**GOVERNMENT/INDUSTRY AERONAUTICAL CHARTING FORUM**  
**Instrument Procedures Group**  
**May 1, 2007**  
**HISTORY RECORD**

**FAA Control # 07-01-275**

**Subject:** Radar Required for Missed Approach

# ILS RWY 35 WILMINGTON INTL (ILM)

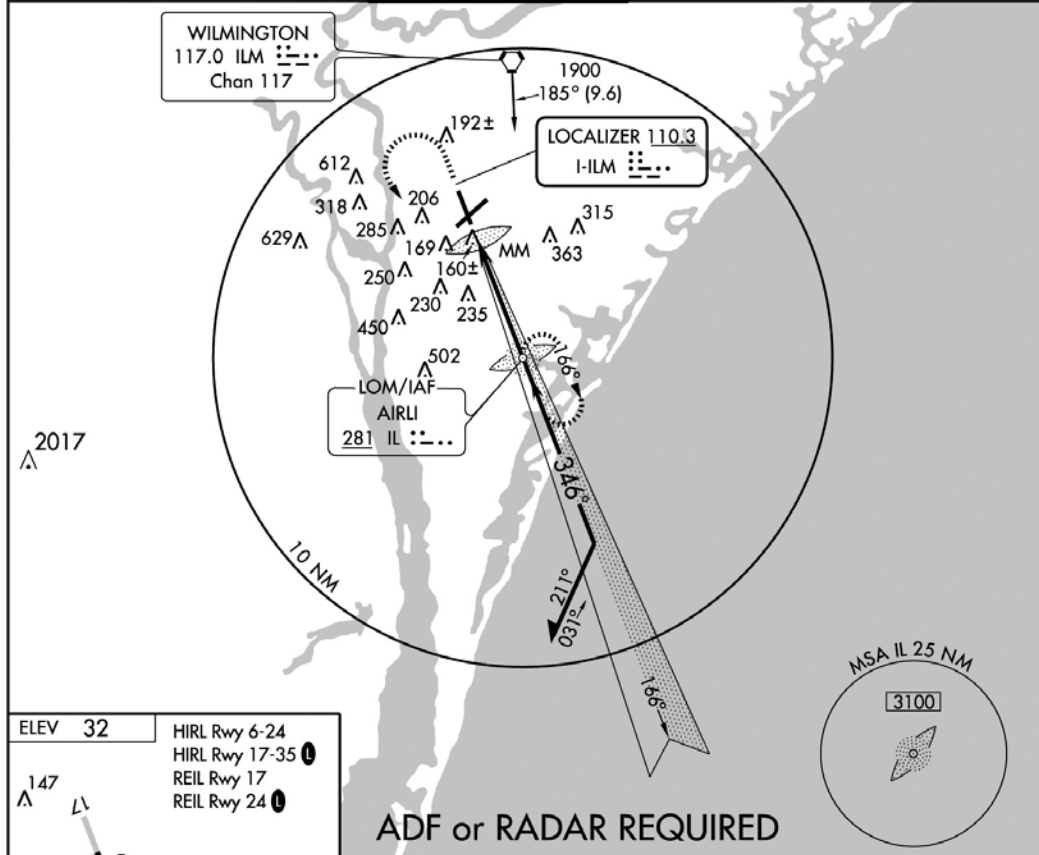
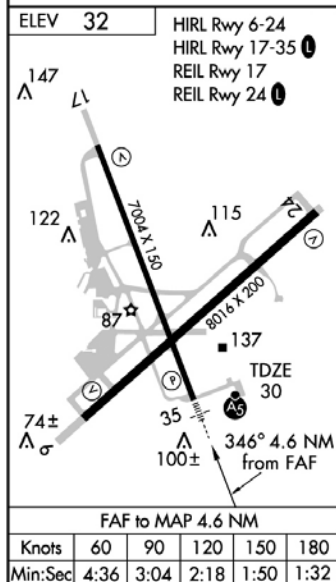
**Background/Discussion:** Attached is a copy of the NACO Chart for the Wilmington Int'l, NC (KILM) ILS RWY 35. The large procedural data note states, "RADAR or ADF REQUIRED." With a casual reading, based on the typical meaning of such notes, many pilots would conclude that either radar or ADF is required for procedure entry. In fact, either ADF or radar is required for the missed approach procedure. Thus, the aircraft without ADF equipment has to "bet on the come" so to speak, that ATC radar vector services will be available in the future event of a missed approach.

The group must carefully consider whether we want to accept radar-required missed approach procedures. This appears to be a recent shift in FAA policy. NBAA is of the impression that Part 121 flights, for example, cannot be dispatched to use a procedure that provides only radar vectors for the missed approach. NBAA requests that the FAA be prepared to confirm or refute this understanding at the meeting for the benefit of the group.

**Recommendations:** Historically, an IAP such as the example attached, would simply state "ADF Required." NBAA urges the group to recommend the FAA return to that more conservative, navaid-based policy.

**Initial Discussion Meeting 07-01:** New Issue presented by Rich Boll, NBAA regarding the procedural data note “RADAR or ADF REQUIRED” on the Wilmington, NC (KILM) ILS RWY 35 approach. NBAA is concerned that many pilots will conclude that either radar or ADF is required for procedure entry. In fact, either ADF or radar is required for the missed approach procedure. Thus, the aircraft without ADF equipment has to “bet on the come” so to speak, that ATC radar vector services will be available in the future event of a missed approach. This appears to be a recent shift in FAA policy as NBAA is of the impression that Part 121 flights, for example, cannot be dispatched to use a procedure that provides only radar vectors for the missed approach. NBAA requests that the FAA be prepared to confirm or refute this understanding at the meeting for the benefit of the group. Historically, an IAP such as the example attached, would simply state “ADF Required.” NBAA urges the group to recommend the FAA return to that more conservative, NAVAID-based policy. Tom Schneider, AFS-420, responded that the plan view note on the approach in question is not in accordance with current guidance in Order 8260.19. There is a terminal route from the en route structure to the IAF. However, the LOM is required for procedure entry and the course reversal maneuver, therefore, a planview note “ADF REQUIRED” is required under Order 8260.19, paragraph 855h(1). ADF or radar is also required for the missed approach; therefore a second equipment note “ADF or RADAR REQUIRED” is required for the briefing strip under paragraph 855h(2). A “RADAR REQUIRED” note in the plan view is only required when radar is the only method for procedure entry from the en route environment under paragraph 855g(2). Brad Rush, AJW-321, took the IOU to amend the procedure.

**MEETING 07-02:** Brad Rush, AJW-321, briefed that a P-NOTAM amending the “ADF or RADAR REQUIRED” note on the Wilmington, NC ILS RWY 35 IAP has been issued. He recommended the issue be closed. Rich Boll, NBAA, concurred. [Item Closed](#).
